STAFF RECOMMENDATION

2404 Blair Boulevard

April 22, 2020

Application: New Construction—Addition; Setback Determination

Figure 2. Proposed right-side façade with window opening to be added.

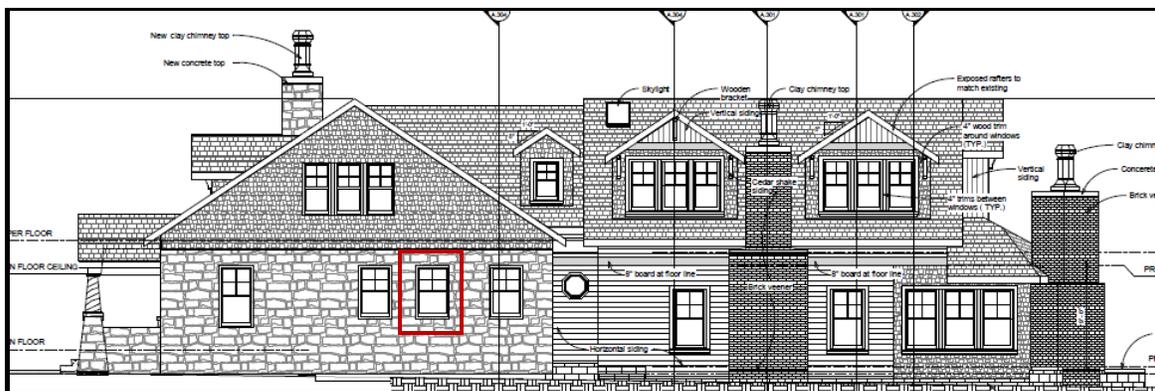
Partial Demolition: The applicant proposes to introduce a new window opening on the right-side façade (Figure 2). Staff finds that adding a new window opening can be appropriate given the location on the side façade beyond the midpoint and since the project does not include relocating or removing an existing window opening which can be more difficult given the historic stone cladding.

Staff finds that the proposed partial demolition meets Section III.B.2 for appropriate demolition and does not meet Section III.B.1 for inappropriate demolition.

2 PROPOSED RIGHT VIEW
A.202 1/4" = 1'-0"

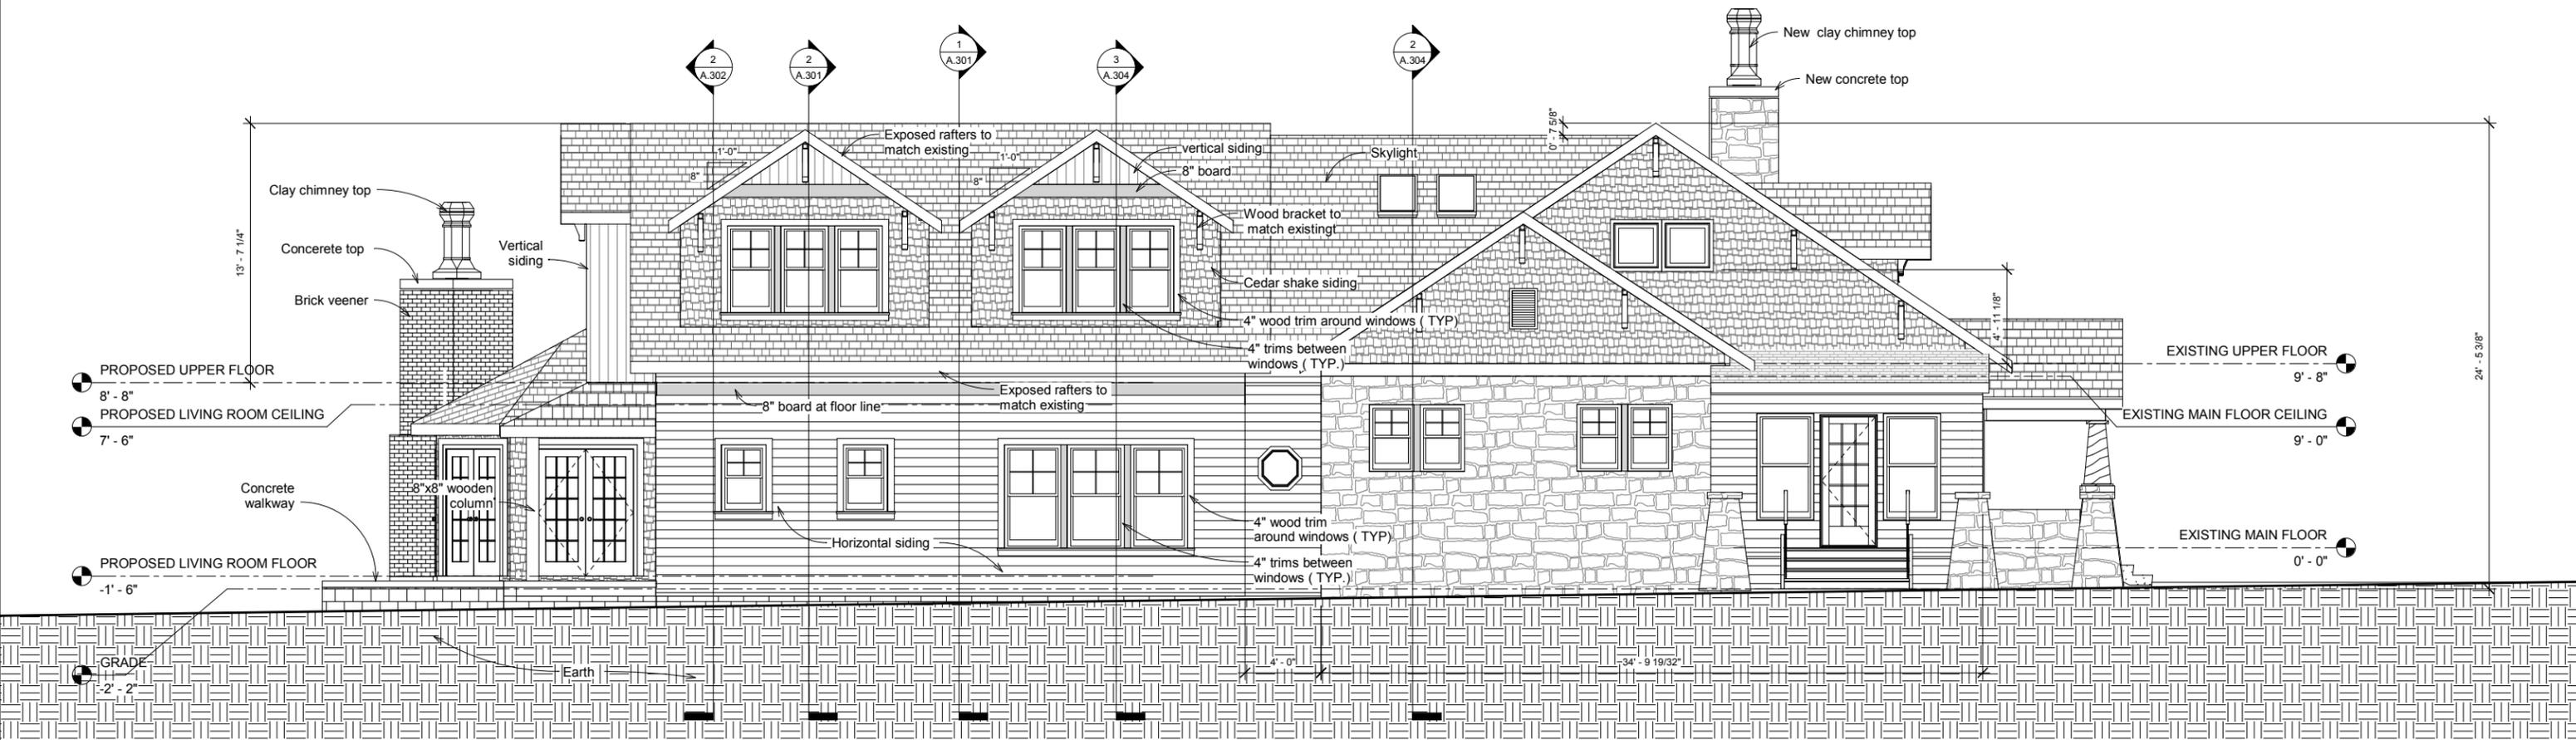
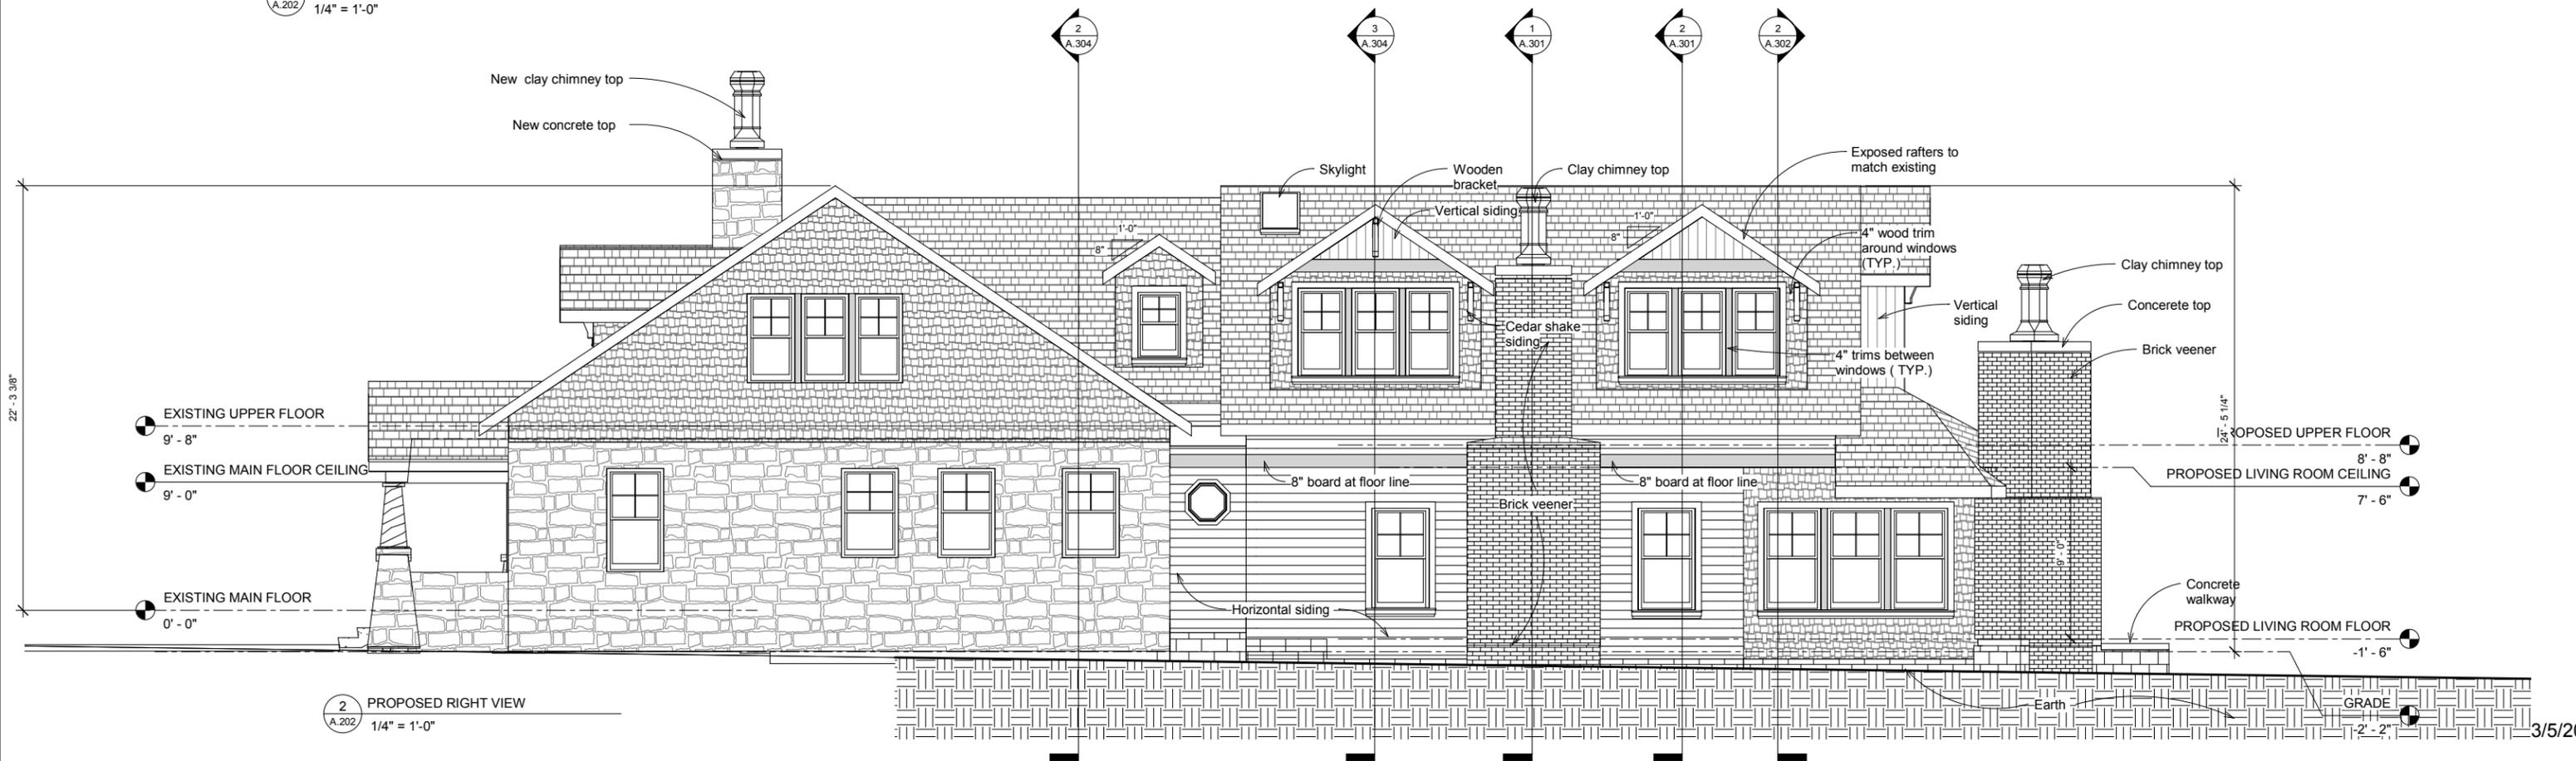
Analysis and Findings: Application is to construct a rear addition that includes a setback determination to reduce the right-side setback from five feet (5') to three feet, six inches (3'-6"). The addition would be no closer to the property line than the historic house. The proposal also includes the addition of a window on the right-side façade of the historic house beyond the midpoint.

Setback & Rhythm of Spacing: The addition will be approximately eighteen feet (18') from the left-side property line and fifty-seven feet (57') from the rear property line, which meets the bulk standards. The historic house sits three feet, six inches (3'-6") from the right-side property line, and the applicant has requested a setback determination to reduce the right-side setback for the addition from five feet (5') to three feet, six inches (3'-6"). Staff finds the setback determination to be appropriate since the addition is inset appropriately and extends no wider than the historic house.

Staff recommends approval of the requested setback determination and finds that the project can meet Section II.B.1.c.

1 PROPOSED SITE PLAN
C.101 1" = 20'-0"

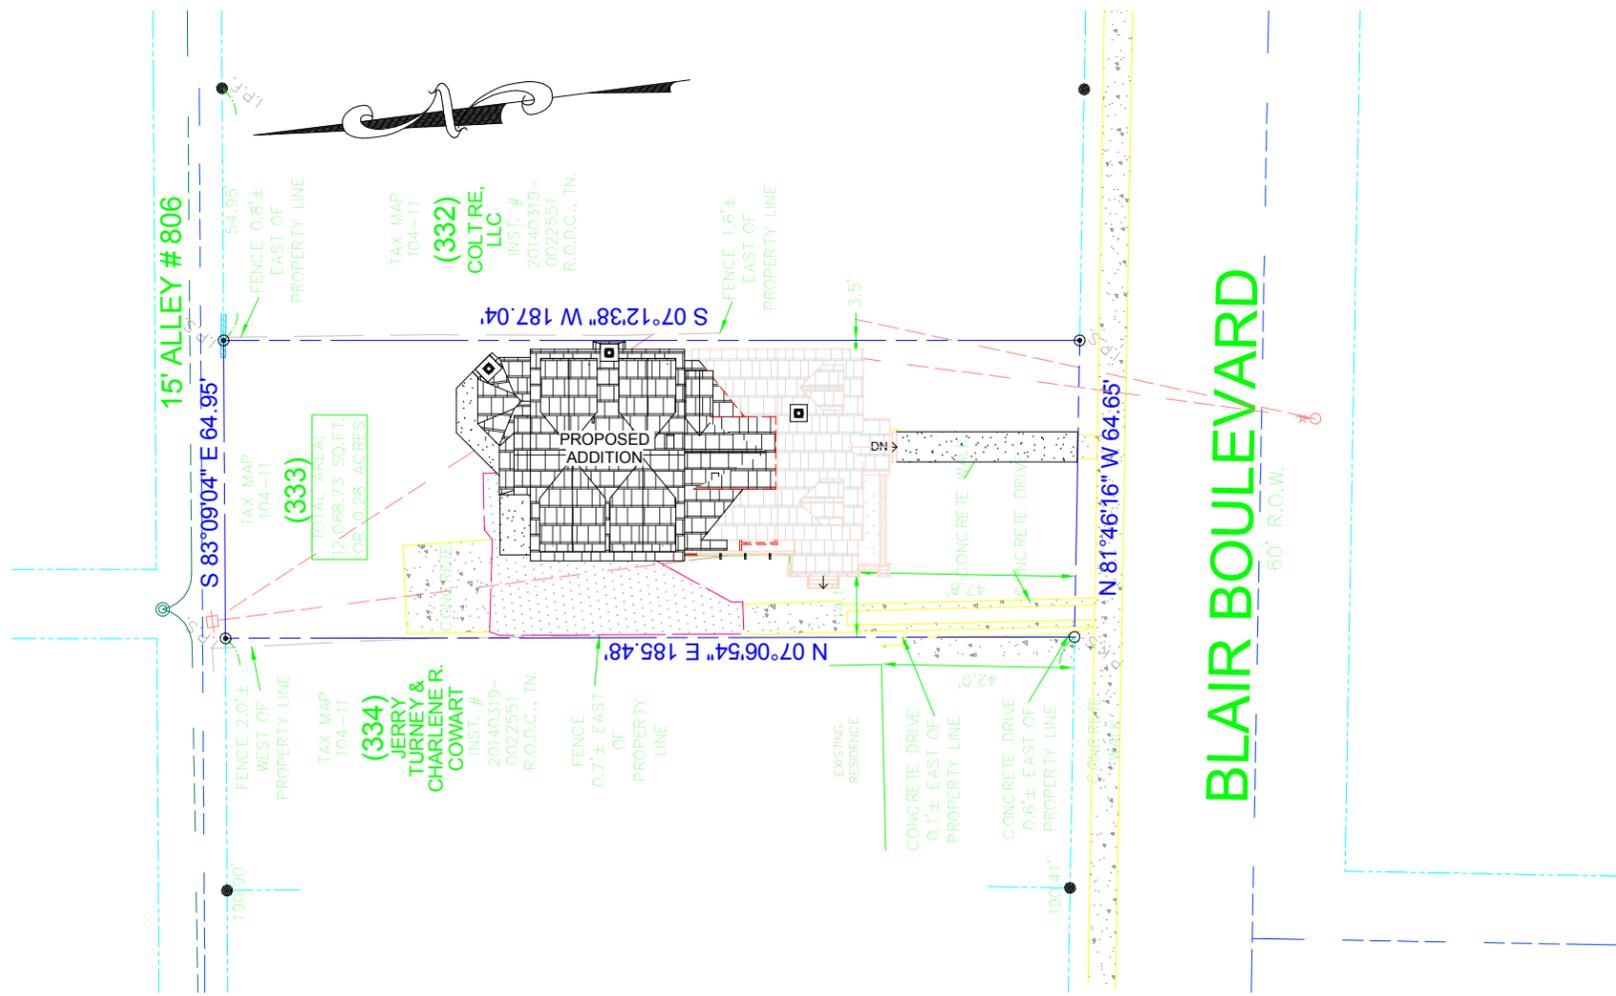
My concern is that they would only have 3.5' to complete maintenance on their home.

We put a fence up before my time and it sits (according to survey), 1.6' over on our property from property line. Just want to make sure they do not encroach on our setbacks or make assumptions. Happy to work with them but want to keep our value in place and not loose options for later expansion on our part because they (2404) moved their home 1.5' over into their setback.
